# Discussion of the Rebound Issue

## ACEA comments for discussion 5. IG-GTR9-PH2

Document TEG-128 (11. TEG Meeting in April 2010)

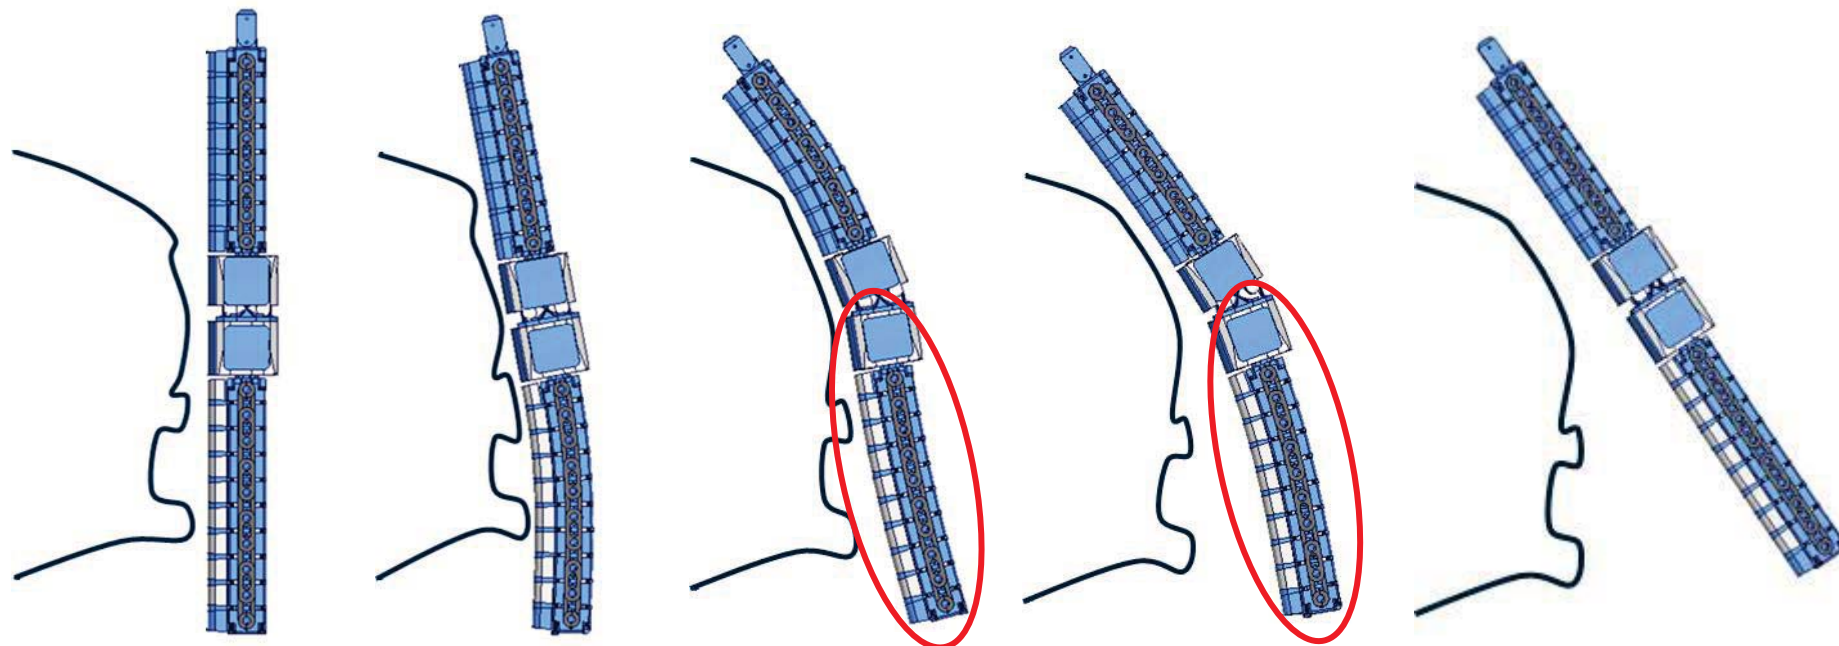
Distinguish between rebound phases for ligament elongations and bending moments

Rebound for tibia measurements is indicated by the first zero-crossing of T1, T2, T3 or T4 after the first maximum.

Timing of zero-crossing can be easily and automatically derived from time-history-curves and is more precise than film analysis

Rebound for ligament measurements remain as proposed by the TEG recommendation (50ms)

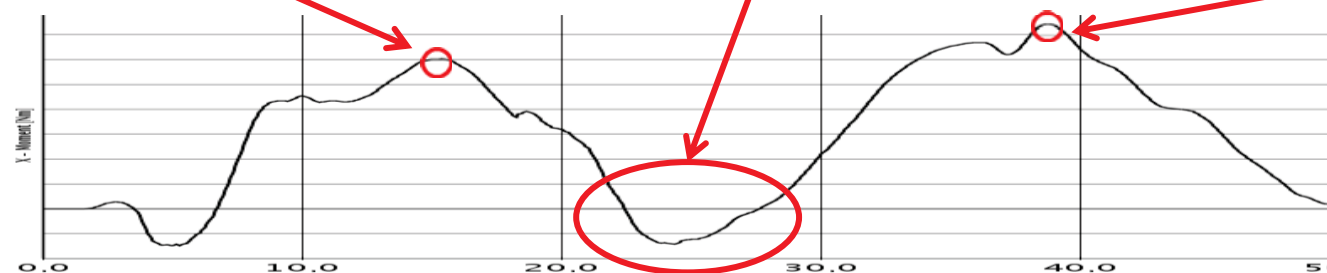
first tibia bending peak  
**contact to vehicle**  
around 15ms

after zero-crossing  
negative tibia moment  
**no contact of tibia to vehicle**

second peak for tibia bending moment occurs  
without contact **to vehicle** due to **swinging of**  
**impactor**
